## **Organization of Woodland Lake (OWL)**

Discussion of concerns and research understandings relative to the Proposed PUD Development

RZ #25/01 FOR THE COVE AT WOODLAND LAKE

## Current PUD Layout

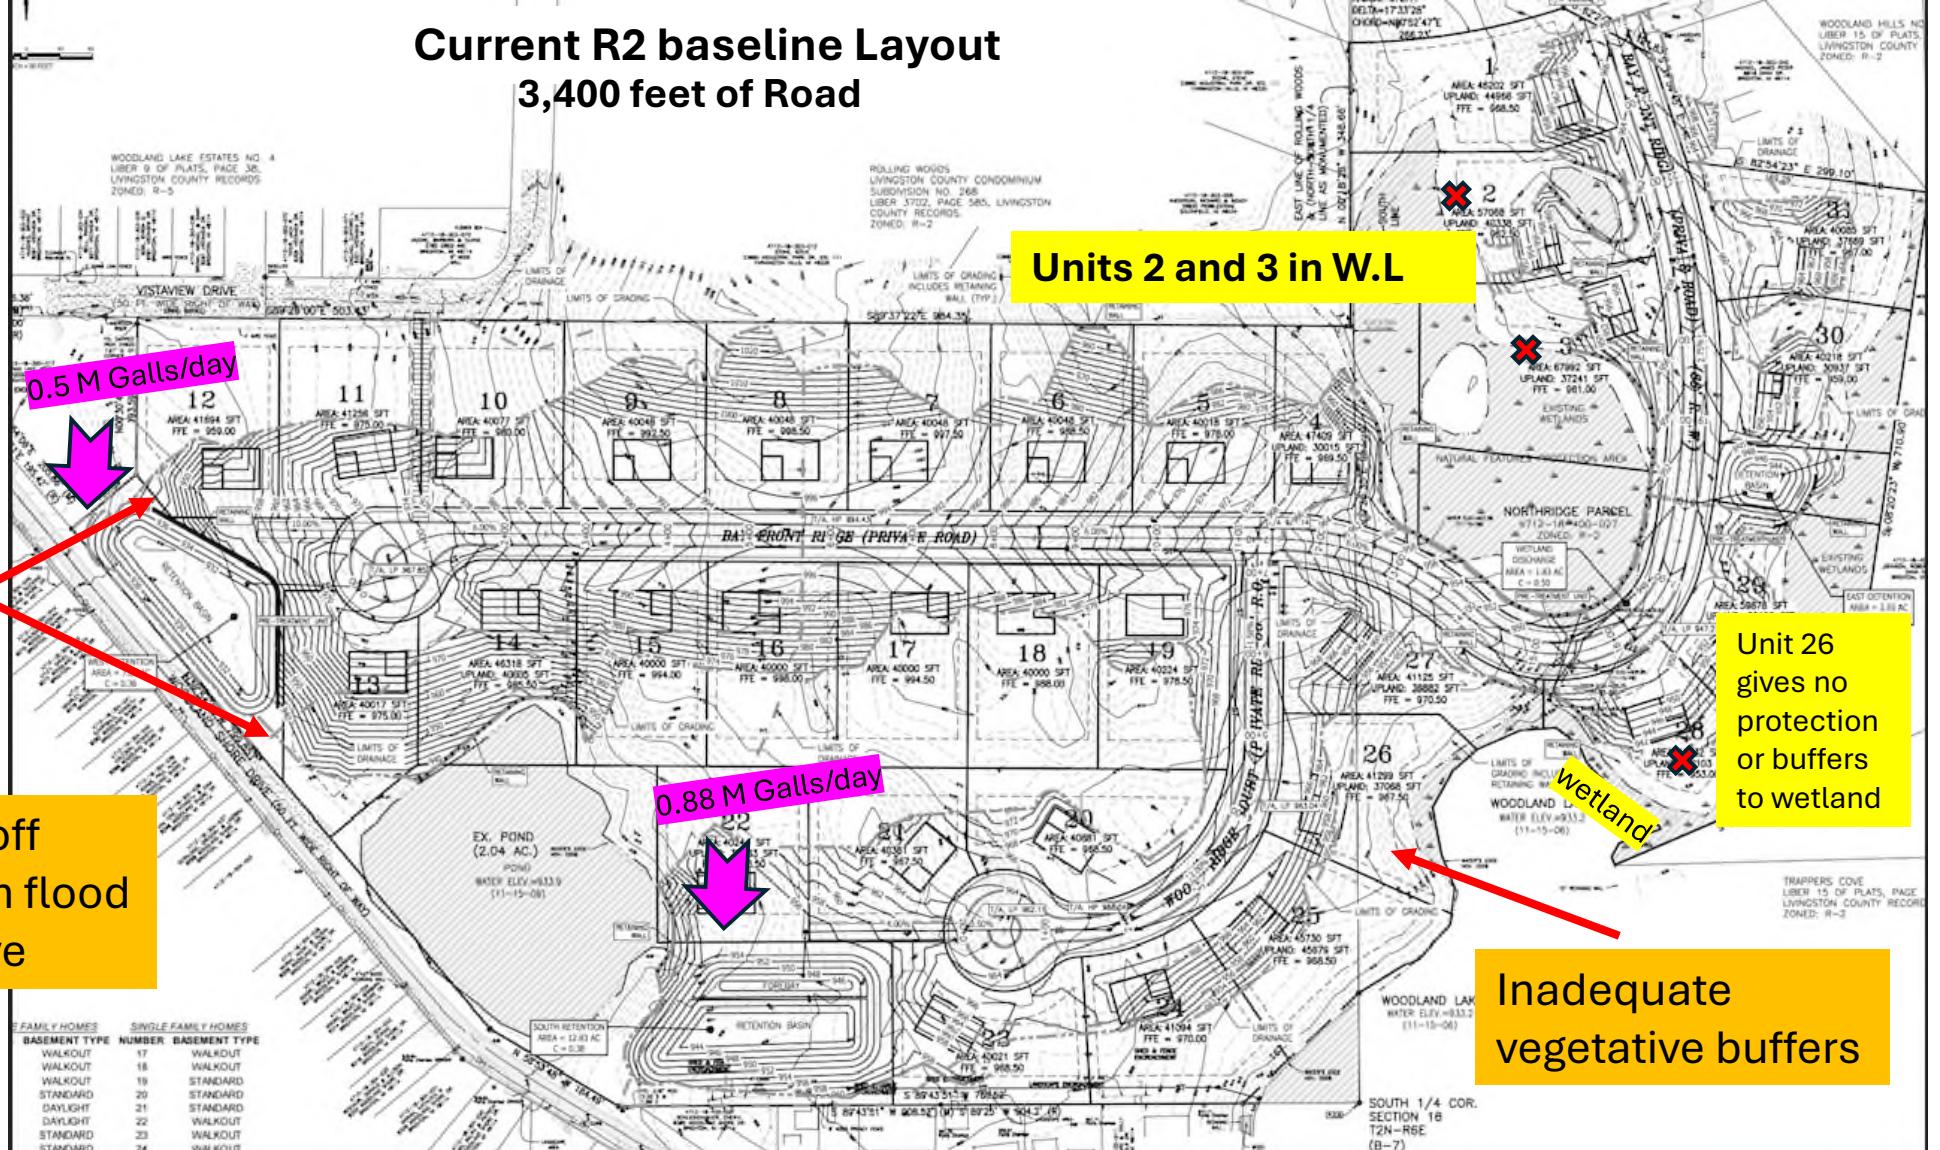
Steep Elevations, 20-80 feet across entire build plan will require extensive work to protect our lake in construction and through full occupancy.

High Density (46% runoff over 20 acres, too many) impervious cover is unacceptable for lakefront, particularly a troubled one

Vegetation buffer zones (engineered) are a great aid to retention and detention ponds. Environmental Engineering necessary

No room for vegetation buffers, swales and adequate retention and nutrient management in this layout

931 elevation to base  
West retention basin

945 elevation for  
south retention basin

## Inadequate vegetative buffers

1.38 M gallons/Day runoff  
Pond not protected from flood  
Nutrient runoff excessive

## Current R2 baseline Layout 3,400 feet of Road

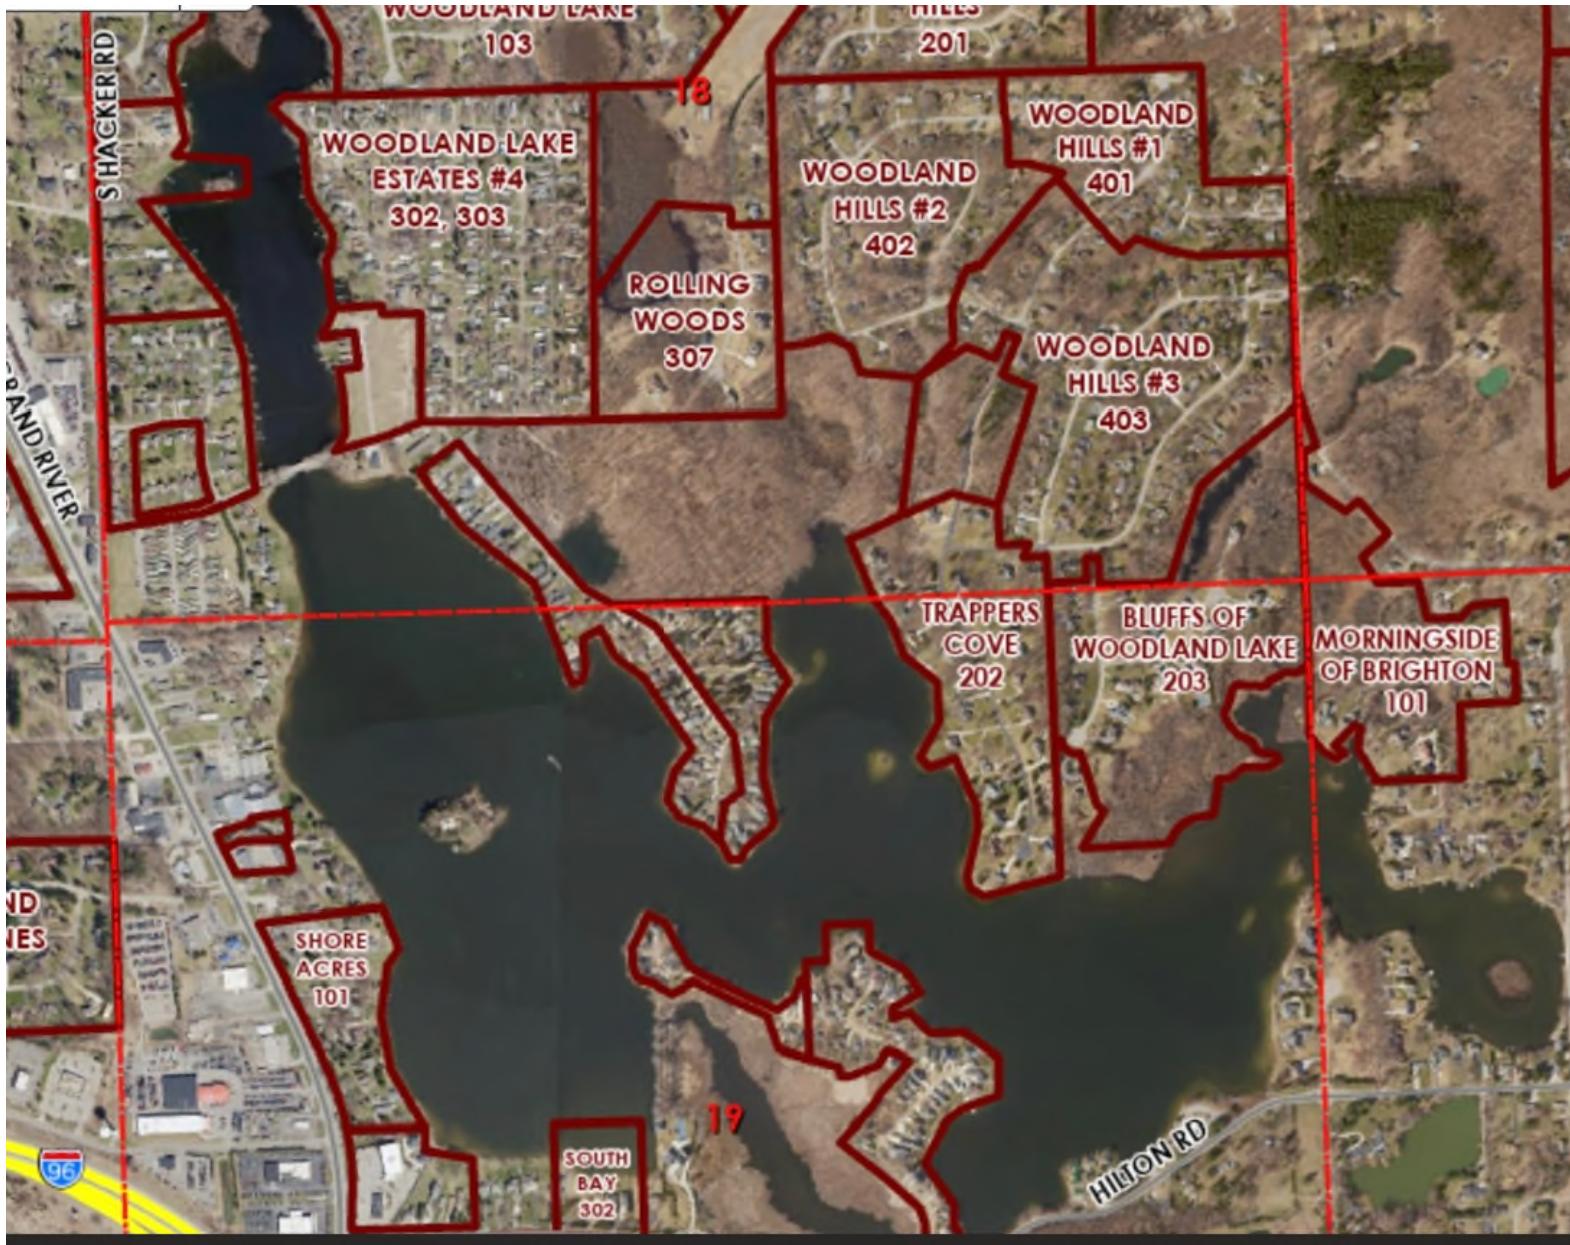
**R2 Baseline as currently designed does not protect our lake, or the pond from flooding. Too much flow for nutrient absorption**

Excessive impervious factor (41% runoff over 25 acres, too many). Over 4.5 times the road length that the master plan specified

## Inadequate room for vegetative buffer zones, inadequate retention and forebay systems

OWL proposed strawman  
compromise

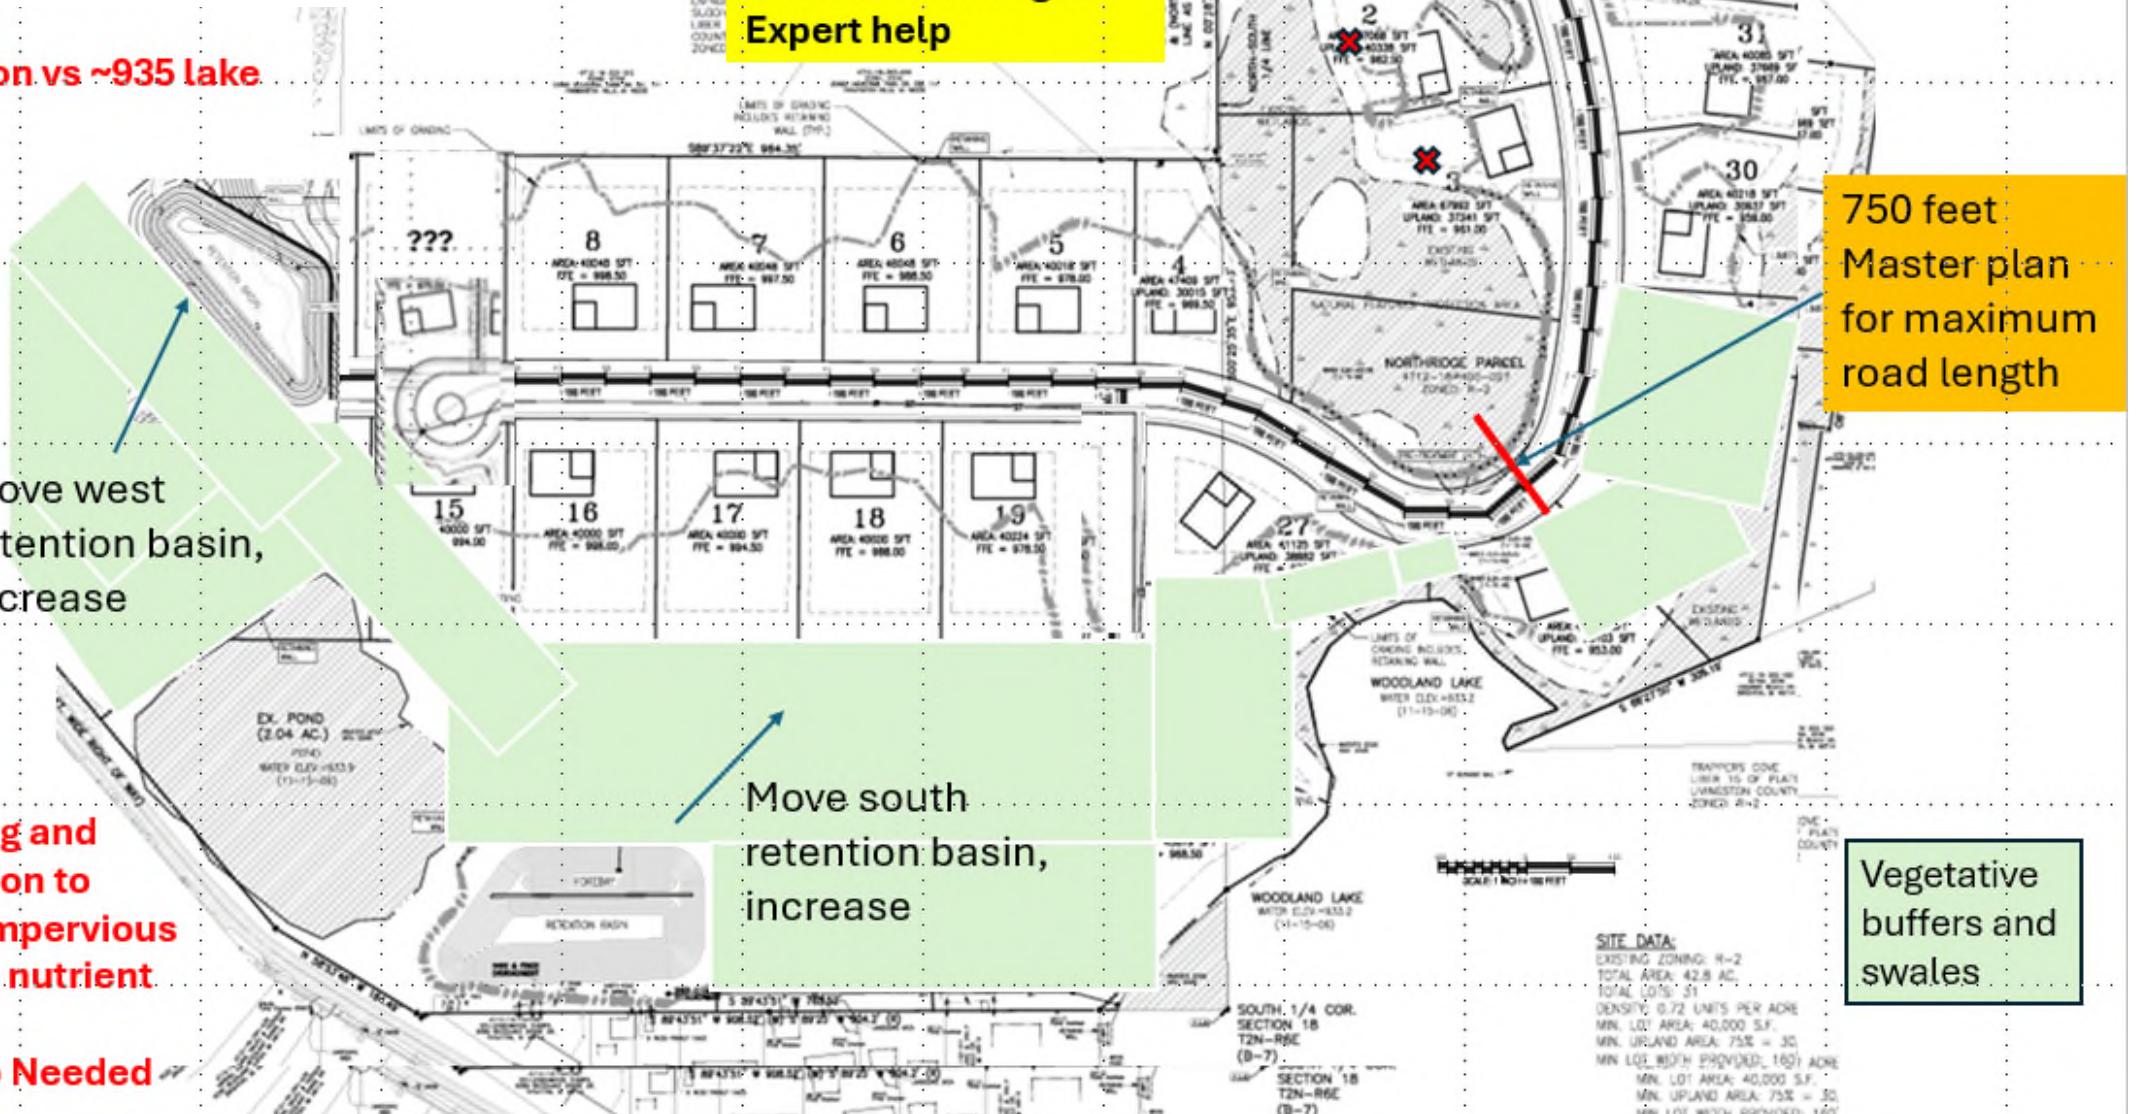
~1450-1800 feet road, Ballpark

960 ft elevation vs ~935 lake

R2 Modified strawman

Units 2 and 3 in W.L.  
Doesn't seem right?  
Expert help

## R2 Baseline plan

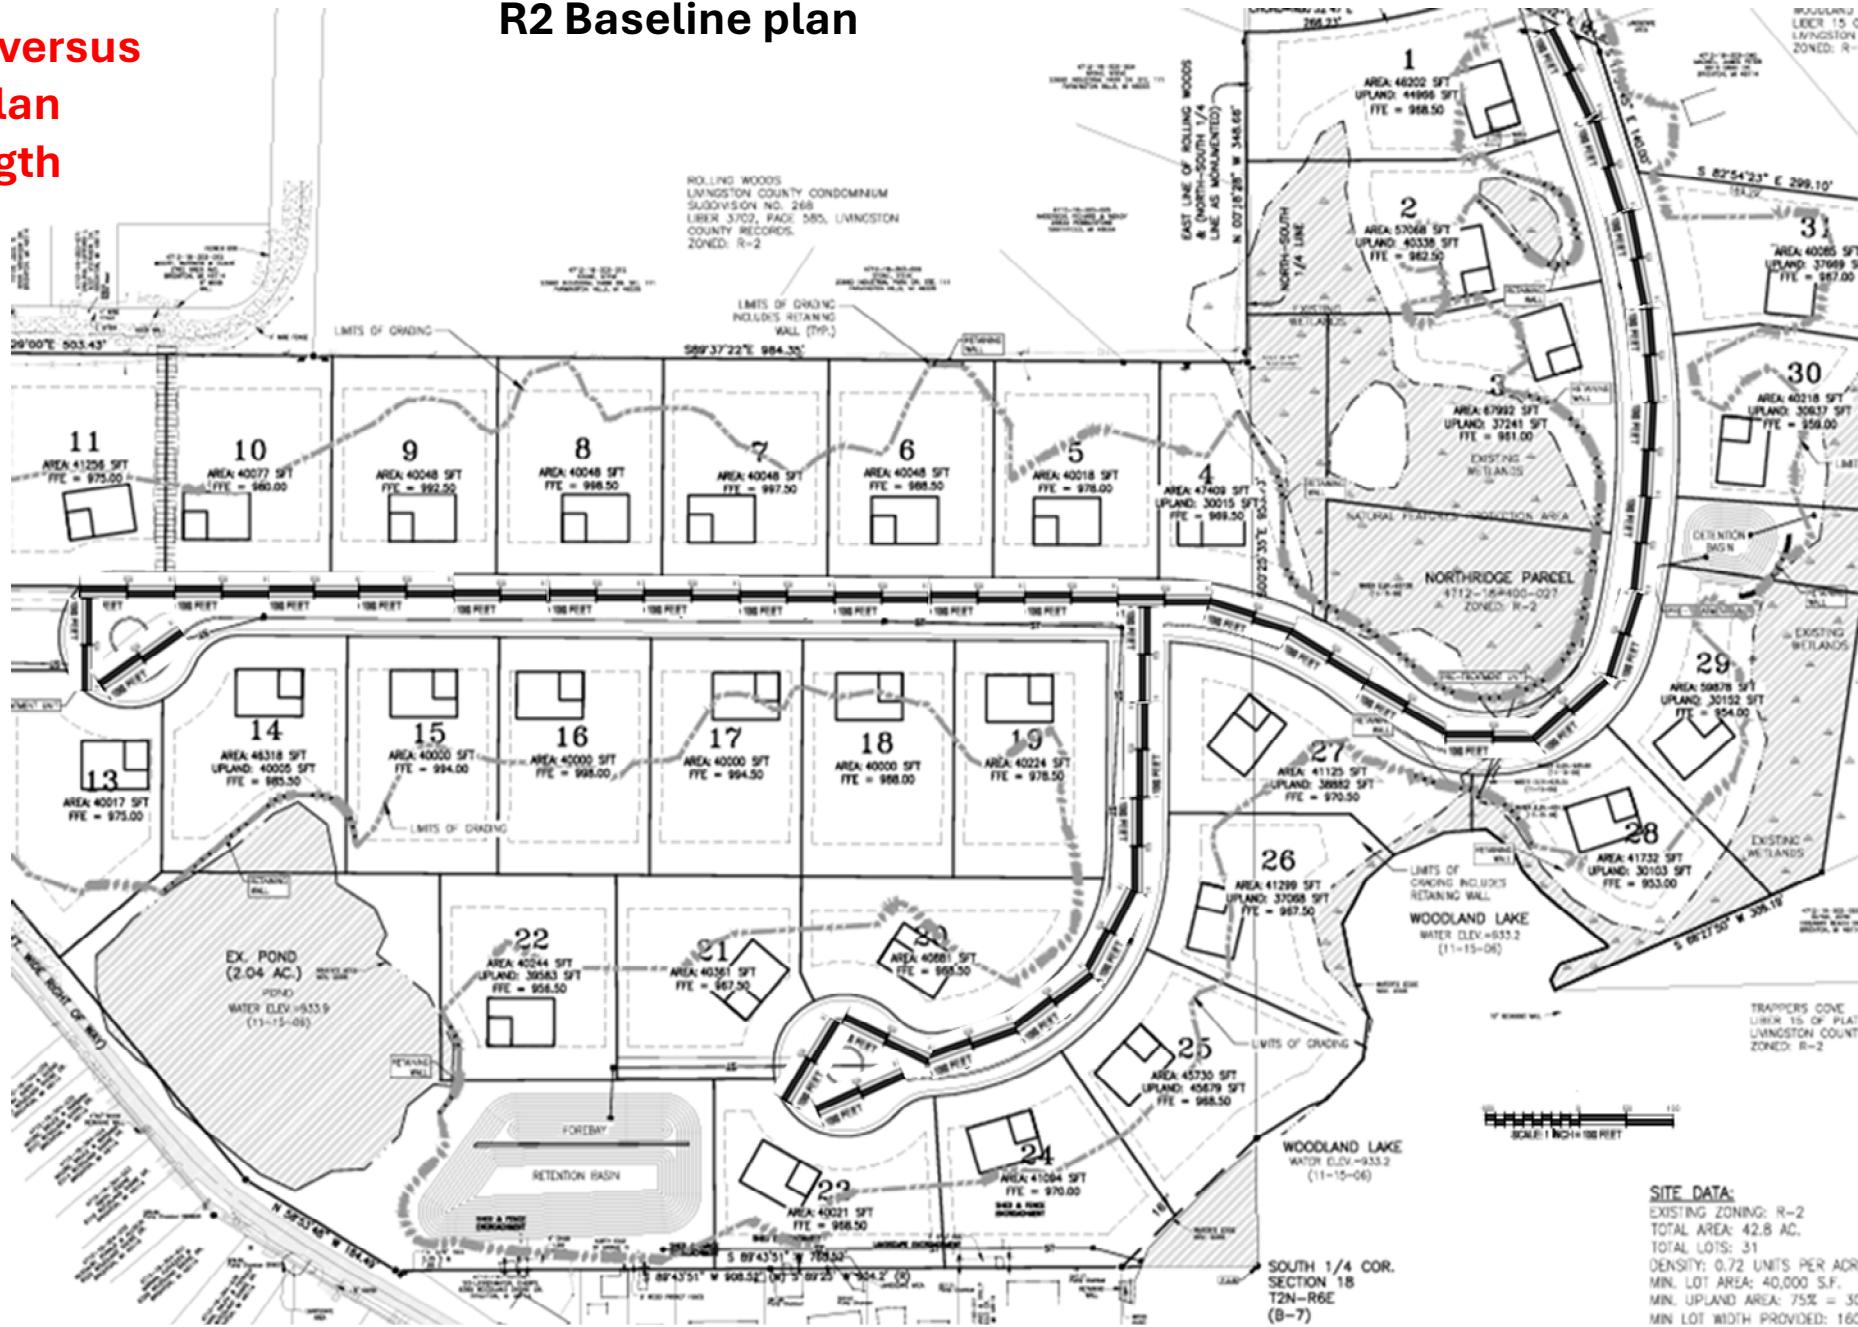
2,888 ft to  
culdesac  
Versus 750  
feet per  
Master Plan

**3,400 ft total versus  
750 Master Plan  
Roadway length**
